**Re: Brick and Machine Project - 9735 Washington Boulevard
Comments on The Project and Proposed Mitigated Negative
Declaration**

This letter contains two main parts: Part 1 responds to the September 28, 2017 Memorandum from ESA PCR (Mike Harden and Jay Ziff) to Jose Mendivil entitled "9735 Washington or 'Brick-Machine' Project – Responses to Allen Matkins Letter," Attachment No. 14 to Agenda item PH-1 (18-0912) of the February. 28, 2018 Planning Commission hearing ("Memorandum"). This segment will set forth the various reasons why the responses provided in the Memorandum are wholly insufficient, as they do not adequately address the issues and concerns raised in the Allen Matkins Letter. The Memorandum was updated on February 14, 2018 with respect to a single issue – "Noise/Vibration Corrections and Revisions" (also included in Attachment No. 14.). The purported "Noise/Vibration Corrections and Revisions" which provide minor refinements to mitigation measures for several of the Noise and Vibrations impacts, do not adequately mitigate the Project's impacts, as addressed in more detail in Sections 1(e) and 2(e) below, and in the attached report from Veneklasen Associates (see Exhib

Figure 1. Potentially Impractical/ Infeasible Construction Logistics Based on Revised Mitigation Measure NOISE-3

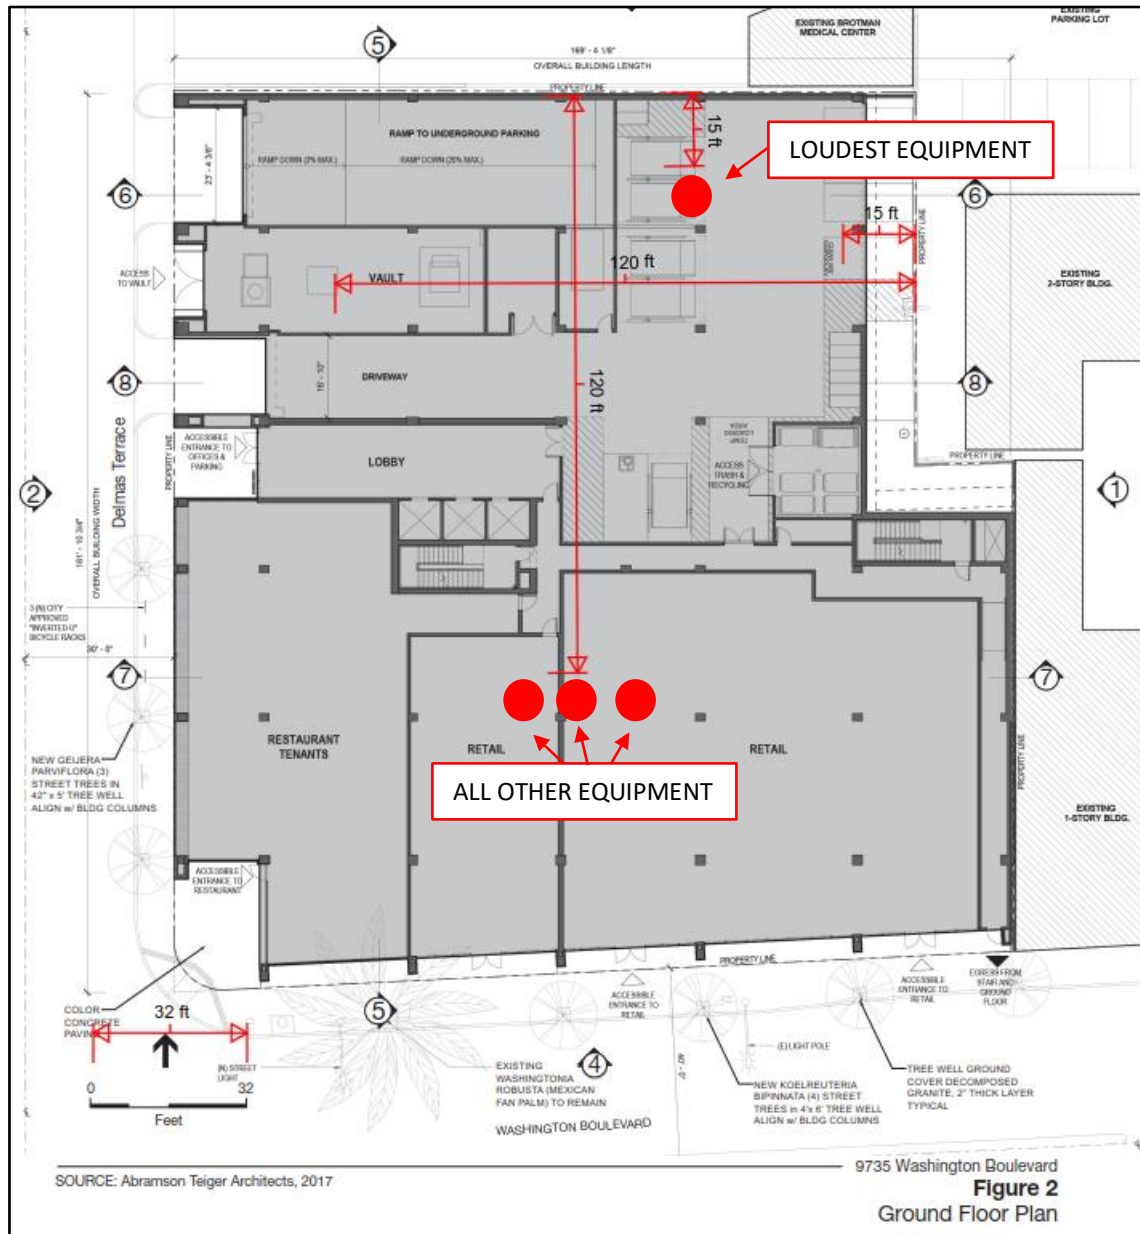
The first, second, and fourth sentences of the fourth paragraph of the response to Comment 14 state, "Mitigation Measure NOISE-3 requires that the simultaneous operation of multiple pieces of equipment be avoided. The mitigation measure has been modified to specifically allow no more than one piece of noise-generating equipment at a time to operate within 15 feet of the adjacent hospital and residential use. All other noise-generating equipment must be operated no closer than 120 feet of the adjacent hospital and residential uses."

These work activity distances/construction logistics are normally impractical and infeasible to construct the proposed project. The City of Culver City Noise Element states that noise level standards are in reference to the property line of the noise sensitive receptor. Please see Figure 1 for an example illustration, utilizing the proposed project design documents, of equipment locations based on revised Mitigation Measure NOISE-3, noted to scale. Furthermore, what are the projected, resulting noise levels due to equipment located just outside of the 15 feet distance threshold? Several pieces of construction equipment located at 16 feet from the property line of the hospital or the nearest residence could result in noise levels well above 91 dBA Leq.

If the noise analysis and mitigation measures have been revised from the original content contained within the IS/MND, then the IS/MND requires formal revision to reflect these changes to support the conclusions within the revisions presented. The revised Mitigation Measure NOISE-1 on page 14 on the Responses to Allen Matkins Letter should be amended to clearly define the distinctions between equipment noise due to engine combustion (mitigatable via noise control devices) and equipment noise due to operational use. One example revision may be, "...achieving a minimum of 10 dB reduction in equipment noise due to internal combustion engine noise." Additionally, revised Mitigation Measure NOISE-3 should be amended to address noise impacts
